Determination 2017/071

The code-compliance of a proposed house with steel framing and polyisocyanurate insulation board at 250 Wills Road, Upper Moutere, Tasman

Figure 1: Section through the proposed house (not to scale)

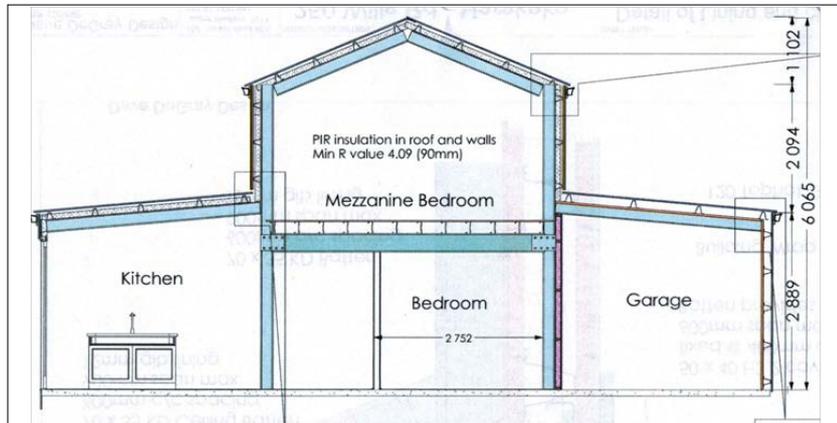
- On Sheet 11, expanded details of section junctions incorrectly show habitable spaces as unlined and the garage space as lined (and conflict with Sheet 15).
- There are no details for plywood cladding joints and junctions (drawings also require updating to accord with the subsequent expanded details).

Figure 2: Typical construction in drawings dated 12 April 2017

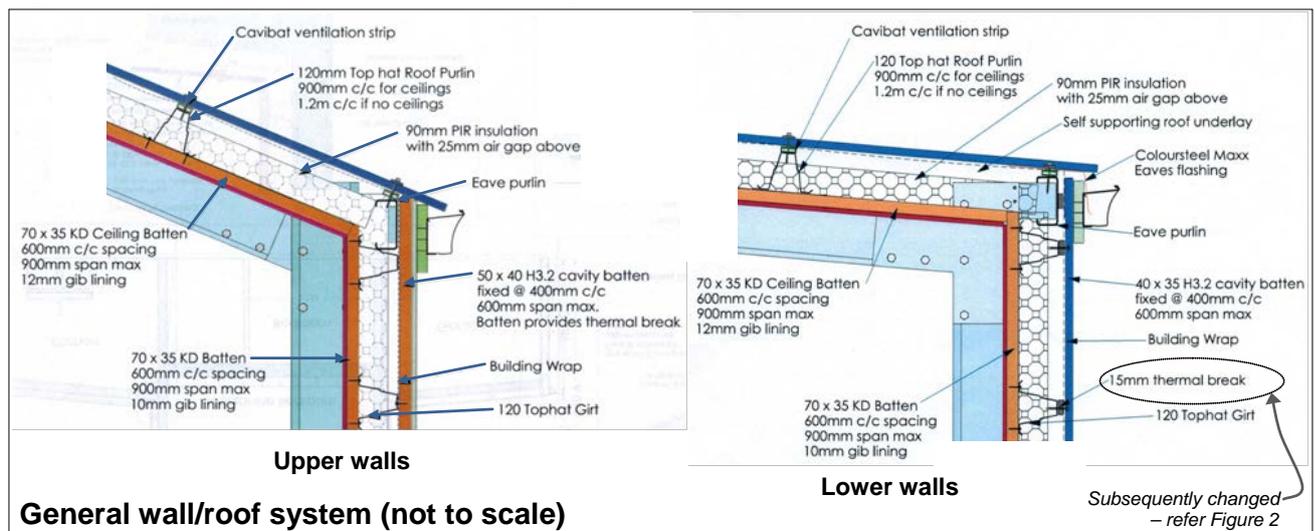
- The additional expanded details show a ventilated batten installed along the face of the horizontal girt, which should allow any condensation to drain past the junctions (Figure 2).
- Although head and sill flashings accord with E2/AS1 Figure 95, the jamb flashing differs and a note should be added to ensure that the sill flashing is extended past the outer edges of the jamb flashings to allow moisture to escape.
- On Sheet 15, the apron flashing upstand lacks a dimension.
- On Sheet 16, the cladding/foundation overlap should be noted as 50mm.

Figure 3: Insulation at steel girts and purlins per drawings dated 29 June 2017

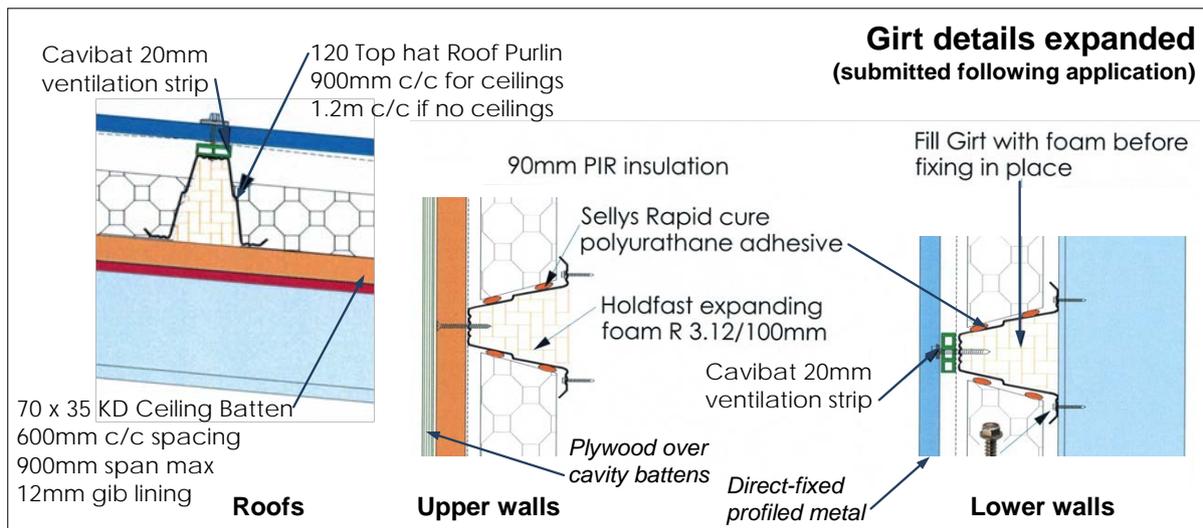
- Although the proprietary batten insulates the steel girt from the profiled metal cladding, parts of the girt are exposed to unheated cavity air – allowing some thermal bridging.

- Better consideration needs to be given to the framing (steel or timber) necessary to support the PIR board at some building junctions – how the PIR board is to be supported is not clear.
